**Flood Control Project Maintenance  
Levee Inspections  
LMA District Cover Sheet**

**Sutter Maintenance Yard Maintenance Area 0001**

**Levee Inspection Report By Mile - Spring 2021**

Waterway	Bank	Unit Miles	Inspection Start/End	Inspector
Unit No. 01 Sacramento River	Right	16.76	03/19/2021 03/19/2021	Makar Sokol

Photo 1 of 3 : UCIP\_SP\_2021\_58090\_70064.jpg

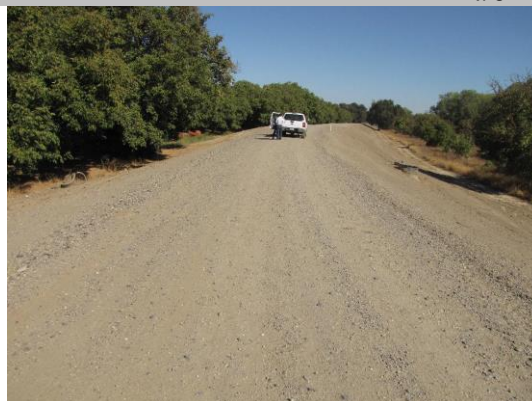
Comment Code						
Inspector Comment						
FS_ID:58090 DS_ID:16430 EP_NO: 9487 Repair Type: Non-Urgent Crossing Status: Found UCIP Comments: 05/03/2017 WS end still partially plugged. (A. Freitag - DWR Sutter Yard)10/24/2016 Ws end is till partially plugged. (A. Freitag - DWR Sutter Yard)04/25/2016 WS pipe end is still plugged with soil. Rest of the pipe appeared to be in good condition. (A. Freitag - DWR Sutter Yard)04/20/2015 WS pipe end is plugged about 50% by soil. (A. Freitag - DWR Sutter Yard)06/18/2014 Same as last inspection. (A. Freitag - DWR Sutter Yard)12/17/2013 Same as last inspection. (A. Freitag - DWR Sutter Yard)07/18/2013 WS pipe end has been reformed but is still clogged about 50% by sediment.10/18/2012 Remove dirt and debris in riser. Outlet deformed and blocked over 50%. Debris-round concrete section on landward side. This crossing was listed in the USACE Periodic Inspections as ID# USACE_CESPK_MA1C_2010_p_0116 for crossing outlet deformed and clogged with dirt. (O. Magana - DWR UCIP) FIELD_STRUCT_DESC: 1 of 2: 36-inch corrugated metal drainage pipe through the levee, approximately 12-15 feet below the crown. Slide gates in corrugated metal pipe (CMP) riser located on the waterside (WS) slope. Pipe daylights on the landside (LS). (36-inch pipe [HLM 1.97] authorized under Automatic Board Order (ABO) issued as Permit No. 9487, 1974 - Jimeno Rancho) [Additional Reference(s): DWR Levee Log, 1992. USACE Sacramento O&M Manual 137, August 1955, (Station 103+18)]. FS Date: 5/19/2017 1:20:00 PM

Photo 1 of 3 : UCIP\_SP\_2021\_58092\_70071.jpg

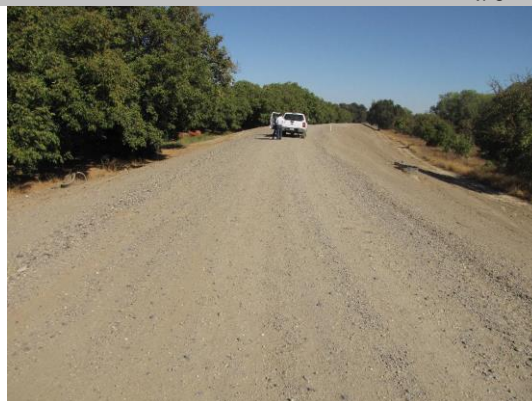
FS\_ID:58092  
DS\_ID:17565  
EP\_NO: 9487  
Repair Type: Non-Urgent  
Crossing Status: Found  
UCIP Comments: 05/03/2017 Ws end still partially plugged. (A. Freitag - DWR Sutter Yard)10/24/2016 Ws pipe end still plugged. (A. Freitag - DWR Sutter Yard)04/25/2016 WS pipe end still plugged with soil. rest of pipe appears in good condition. (A. Freitag - DWR Sutter Yard)04/20/2015 WS pipe end plugged about 50% by soil. (A. Freitag - DWR Sutter Yard)06/18/2014 Same as last inspection. (A. Freitag - DWR Sutter Yard)12/17/2013 Same as last inspection. (A. Freitag - DWR Sutter Yard)07/18/2013 WS pipe end has been reformed but is still partially blocked with dirt and debris.10/18/2012 WS-remove dirt and debris in riser. Outlet deformed and blocked over 50%. Burrow activity near outlet on waterward slope. Debris around concrete section on landward side. This crossing was listed in the USACE Periodic Inspections as ID# USACE\_CESPK\_MA1C\_2010\_p\_0116 for crossing outlet deformed and clogged with dirt. (O. Magana - DWR UCIP)

FIELD\_STRUCT\_DESC: 2 of 2: 36-inch corrugated metal drainage pipe through the levee, approximately 12-15 feet below the crown. Slide gates in corrugated metal pipe (CMP) riser on the waterside (WS) slope. Pipe daylights on the landside (LS). (36-inch pipe [HLM 1.97] authorized under Automatic Board Order (ABO) issued as Permit No. 9487, 1974 - Jimeno Rancho) [Additional Reference(s): DWR Levee Log, 1992. USACE Sacramento O&M Manual 137, August 1955, (Station 103+18)].  
FS Date: 5/19/2017 1:21:00 PM

Photo 1 of 3 : UCIP\_SP\_2021\_53053\_70267.jpg

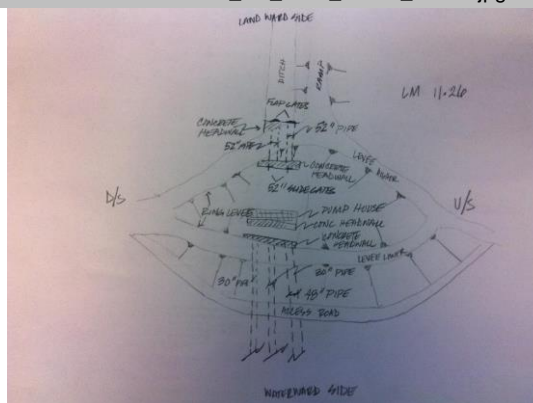
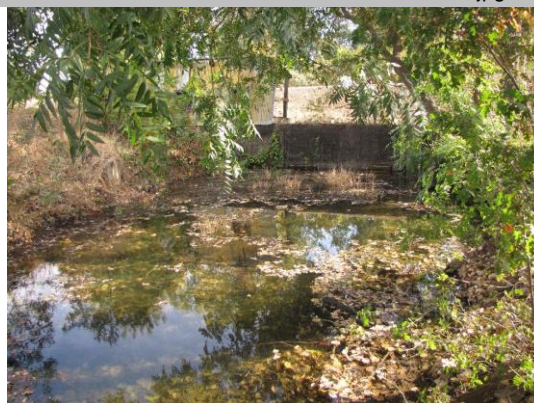
FS\_ID:53053  
DS\_ID:16449  
EP\_NO: 187  
Repair Type: Non-Urgent  
Crossing Status: Found  
UCIP Comments: 10/1/2018 Pipe closed by steel plate at LS end. Plate is bolted to concrete headwall. CVFPB is working with owner to address issue. (O.Yakimov - DWR UCIP)5/3/2017 No changes have been made to this crossing since the NOV was sent out in January 2017. (DWR Sutter Yard- AFreitag)01/31/2017 Informal Notice of Violation (NOV) was sent out January 31, 2017 by DWR Flood Maintenance Office--owner will need to coordinate with CVFPB to remove, replace, or abandon pipe in-place. Owner has until Monday February 27th, 2017 to repond to DWR contact: Bryan Reniff. (refer to Official Notice for details). (DWR UCIP - O. Magana)10/24/2016 Appears abandoned. Slide gate needs to be dug out and fully closed to prevent water flow during high water.(DWR Sutter Yard- AFreitag)4/25/2016 Crossing appears to be abandoned.4/21/2015 Same as last inspection.6/23/2014 Same as last inspection.12/17/2013 Same as last inspection.7/18/2013 Same as last inspection.10/30/2012 Need to determine if structure is still in use--contact owner. If abandoned structure--structure needs to be properly abandoned. This crossing was listed in the USACE Periodic Inspections as ID# USACE\_CESPK\_MA1C\_2010\_p\_0393 missing gate.

FIELD\_STRUCT\_DESC: 1 of 2: 52-inch corrugated metal irrigation pipe, 48-inch measured, through the levee, approximately 15 feet below the crown. Slide gate on the waterside (WS) and flap gate on the landside (LS). Concrete headwalls at both WS and LS. This structure is associated with another abandoned structure located on the WS. Abandoned structure includes pump house, multiple concrete walls, and 3 additional crossings (two 30-inch pipes and one 48-inch pipe). (Original structure installed under Permit No. 187, 1921 - Compton-Delevan Irrigation District-Maxwell I.D., new pump and platform installed and old pump house removed under Permit No. 9183-1973, Maxwell Irrigation District) [Additional Reference(s): DWR Levee Log, 1992].  
FS Date: 10/1/2018 3:42:41 PM

Photo 1 of 3 : UCIP\_SP\_2021\_53052\_70272.jpg

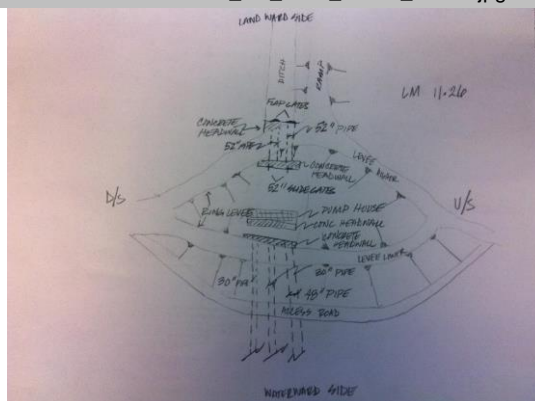
UCIP Comments: 10/1/2018 Pipe closed by steel plate at LS end. Plate is bolted to concrete headwall. CVFPB is working with owner to address issue. Crossing remains "Urgent" because of missing slide gate on WS. (O.Yakimov - DWR UCIP)5/3/2017 No changes have been made at this crossing since the NOV was sent out in January 2017. (DWR Sutter Yard- AFreitag)01/31/2017 Informal Notice of Violation (NOV) was sent out January 31, 2017 by DWR Flood Maintenance Office--owner will need to coordinate with CVFPB to remove, replace, or abandon pipe in-place. Owner has until Monday February 27th, 2017 to respond to DWR contact: Bryan Reniff. (refer to Official Notice for details). (DWR UCIP - O. Magana)10/24/2016 Appears abandoned. Slide gate needs to be replaced or pipe end capped to prevent water flow during high water. (DWR Sutter Yard- AFreitag)4/25/2016 Crossing appears to be abandoned. Slide gate needs to be replaced or pipe needs to be plugged to prevent water flow during high water season. (DWR Sutter Yard - afreitag)4/21/2015 Same as last inspection. (DWR Sutter Yard - afreitag)6/23/2014 Same as last inspection. (DWR Sutter Yard - afreitag)12/17/2013 Same as last inspection. (DWR Sutter Yard - afreitag)7/18/2013 Same as last inspection. (DWR Sutter Yard - afreitag)10/30/2012 Missing positive closure device. Need to determine if structure is still in use--contact owner. If abandoned structure--structure needs to be abandoned properly. This crossing was listed in the USACE Periodic Inspections as ID# USACE\_CESPK\_MA1C\_2010\_p\_0393 missing gate. (DWR UCIP - omagana)

FIELD\_STRUCT\_DESC: 2 of 2: 52-inch corrugated metal irrigation pipe, 48-inch measured (2012), through the levee, approximately 15 feet below the crown. Slide gate on the waterside (WS) and flap gate on the landside (LS). Concrete headwalls at both ends. This structure is associated with another abandoned structure located on the WS. Abandoned structure includes pump house, multiple concrete walls, and 3 additional crossings (two 30-inch pipes and one 48-inch pipe). (Original structure installed under Permit No. 187, 1921 - Compton-Delevan Irrigation District-Maxwell I.D., new pump and platform installed and old pump house removed under Permit No. 9183-1973, Maxwell Irrigation District) [Additional Reference(s): DWR Levee Log, 1992].

Photo 1 of 3 : UCIP\_SP\_2021\_51900\_70342.jpg

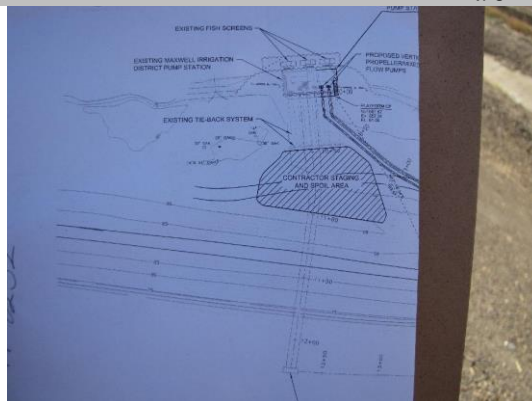
Comment Code						
Inspector Comment						
FS_ID:51900 DS_ID:20584 EP_NO: N/A Repair Type: Non-Urgent Crossing Status: Found UCIP Comments: 5/3/2017 Crossing appears to be in good condition. (DWR Sutter Yard- AFreitag)10/24/2016 appears to be in good condition.(DWR Sutter Yard- AFreitag)4/25/2016 Crossing appears to be in good condition.4/21/2015 Same as last inspection.6/23/2014 Same as last inspection.12/17/2013 Same as last inspection.7/22/2013 Same as last inspection.10/30/2012 Need to determine encroachment permit for this crossing. FIELD_STRUCT_DESC: [Maxwell Irrigation District] 3 of 3: 24-inch steel irrigation pipe through the levee at an unknown depth below the crown. Crossing is tied to existing Maxwell Irrigation District Pump Station located on the waterside (WS). Siphon breaker inside corrugated metal pipe (CMP) riser located on the landside (LS) shoulder. No permit has been identified since crossing was field discovered in 2012. FS Date: 5/23/2017 11:47:50 AM
